Field Remedy: 2604

Subject: Engine A/Z16/18XER - Booming Noise between 2500 – 3500 rpm

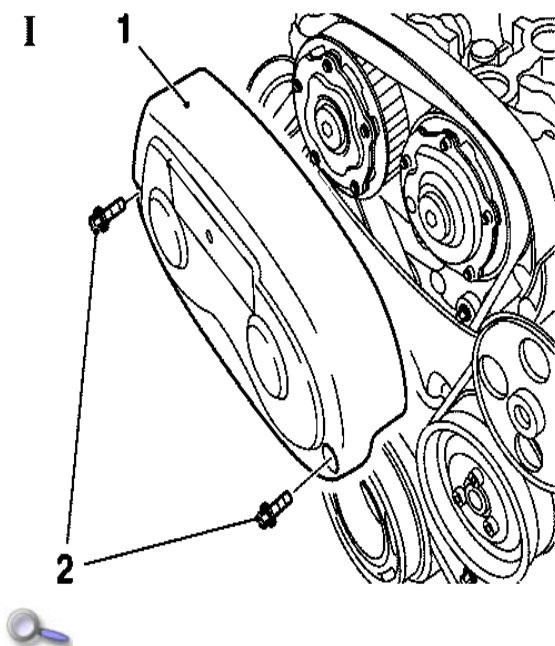
1. Remove upper timing belt cover (Picture I, 1).

- unscrew 2 bolts (2)

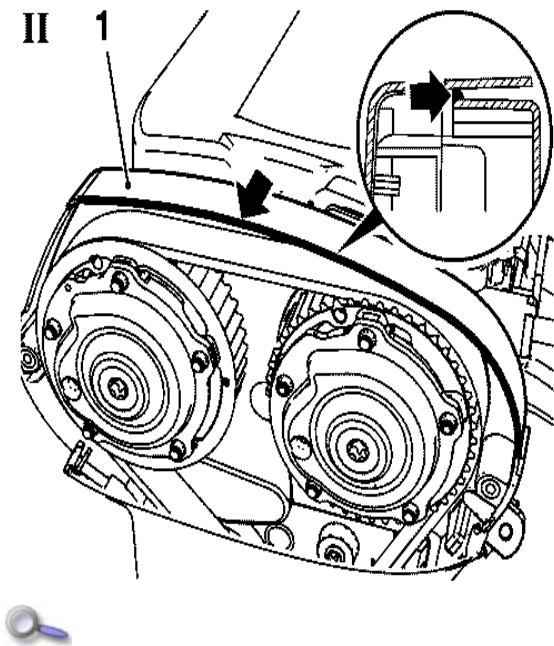
3. Remove burr (Picture II, arrows) from rear timing belt cover (1).

Remove burr with a suitable tool.
Protect timing belt drive from contamination.
